Date of Issue: February 2016

Affected Publication: API Specification 6A, *Specification for Wellhead and Christmas Tree Equipment*, Twentieth Edition, October 2010

ERRATA 8

Page 198, Table 87 (continued):

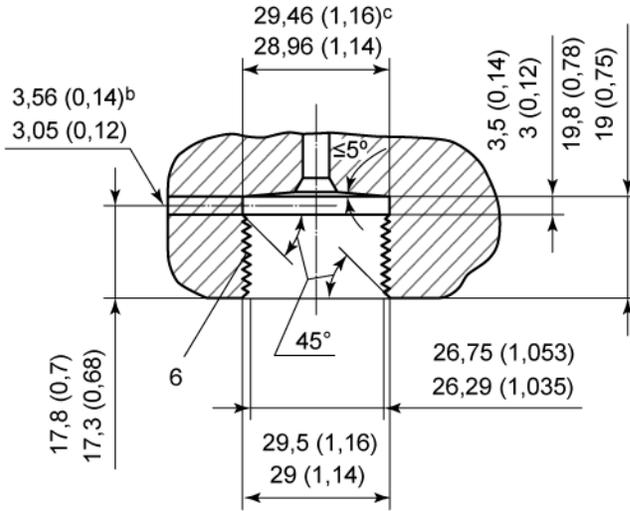
The first two columns, for **13,8 MPa**, **20,7 MPa**, and **34,5 MPa**, should read as follows:

Nominal size and bore	
Vertical B_V +0,8 0	Outlet B_0 +0,8 0
13,8 MPa	
52	52
65	52
65	65
79	52
79	65
79	79
103	52
103	65
103	79
103	103
20,7 MPa	
79	52
79	65
79	79
103	52
103	65
103	79
103	103
34,5 MPa	
52	52
65	52
65	65
79	52
79	65
79	79
103	52
103	65
103	79
103	103
130	52
130	65
130	79
130	103
130	130
